MIDLAND - D. Gillen's Status Report

SUBJECT: MIDLAND UNITS 1 & 2 - GEOTECHNICAL ENGINEERING
PROBLEMS RELATED TO PLANT FILL

Midland Units 1 & 2

History of Geotechnical Engineering Problems Related to Plant Fill

A. Administration Building (Non-Cat. I): First Indication

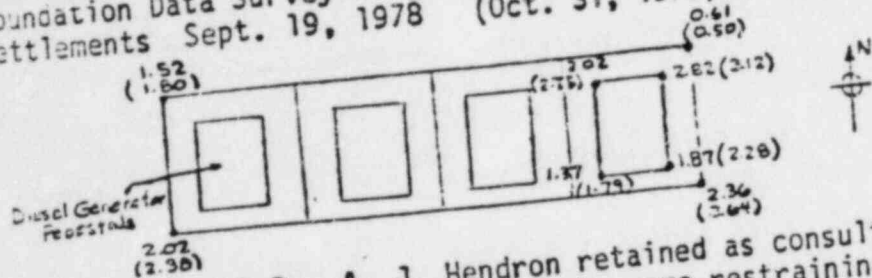
2. Early Sept. 1977; Excessive settlements noted

3. Removal of Column PA0.4 revealed soft foundation material

4. Subsequent investigations & tests. resulted in the conclusion that material under and adjacent to the subject footings had insufficient bearing capacity (insufficiently compacted fill (clay))
5. Soft materials removed and replaced with lean concrete and footings reconstructed

- c. Recent change to permanent dewatering system to replace chemical grouting (see Page 3.)
16. Settlement of D.G. Bldg under 20 ft. of surcharge (6-29-79) (in inches)

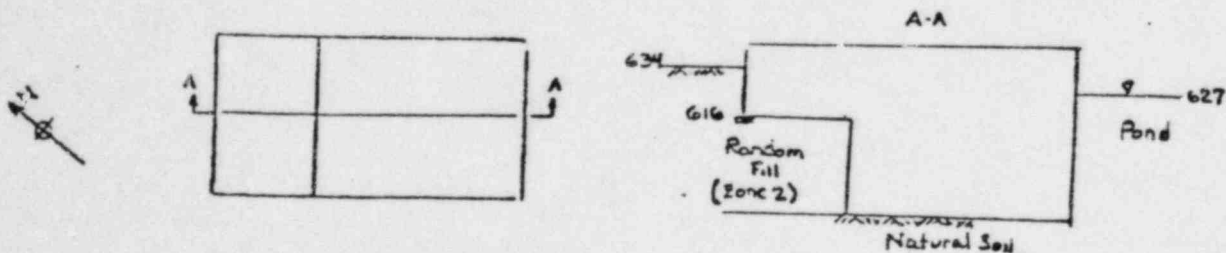
15. Liquefaction analysis of loose sand fill beneath DG Bldg.
 - a. Indicates sands (NW Quadrant) are susceptible to liquefaction
 - b. Proposed chemical grouting to stabilize sands

17. Present plans call for removal of preload in September, 1979.
18. Preload (full scale load test) data will provide relationship between settlement and load \Rightarrow used to predict residual settlements of structure

2. Plan and Cross Section

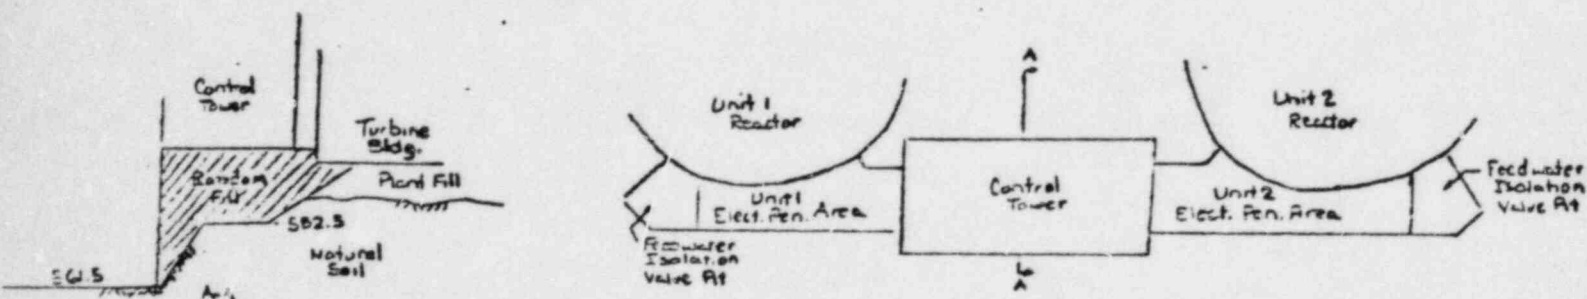
3. Soil Exploration
 - a. Twelve borings made in area
 - b. Control Tower (3 borings)
 - Medium to very dense sand backfill over glacial till
 - local void under mudmat Elev. 590-589 (boring Ax-9)
 - c. Unit 1 Electrical Penetration Area (2 borings)
 - dense to very dense sand backfill with occasional layers of loose sand and soft clay over glacial till - layer of concrete Elev. 583.5 to 580.

- d. Unit 2 Electrical Penetration Area (2 borings)
 - Generally same as C.
- e. Units 1 and 2 Feedwater Isolation Valve Pits (5 borings)
 - Loose to dense sand and medium to very stiff clay backfill with occasional soft zones over dense glacial till - concrete used as backfill in spots

4. Deficiencies

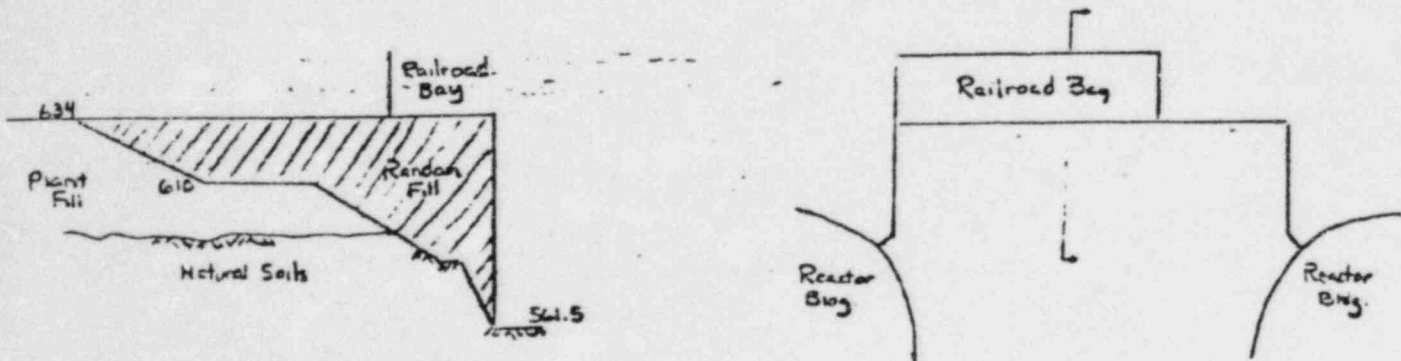
- a. Void under concrete mudmat in control tower area
- b. Backfill material under electrical penetration areas and valve pits has not been sufficiently compacted

- a. Pressure grouting to fill the void under the mudmat.
- b. Unsuitable backfill under elect. pen. areas and valve pits removed and replaced by lean concrete \geq 2000 psi comp. strength

- Temporary support for valve pits \Rightarrow supported externally from turbine bldg. and buttress access shaft
 - If external support of Elect. Pen. areas is necessary, steel girder resting on containment ring girder and turbine building crane column will be provided.

- Instrumentation installed to monitor the movements of Elec. Pen. areas during dewatering and excavation operations
 - Excavation areas will be dewatered

- When dewatering has lowered GWT to Elevation 600 ft., access shafts will be dug from 634' to 603' and tunnels made under valve pits
 - Temporary support system installed under the ends of the electrical penetration areas jacked piles, caissons or concrete piers.

- Excavation and removal of unsuitable fill will be done by manual or mechanical means
 - Upon completion of excavation, the excavated area will be backfilled with lean concrete; 5 ft maximum lift thickness (first lift 2 ft); successive lifts doweled into preceding lift.
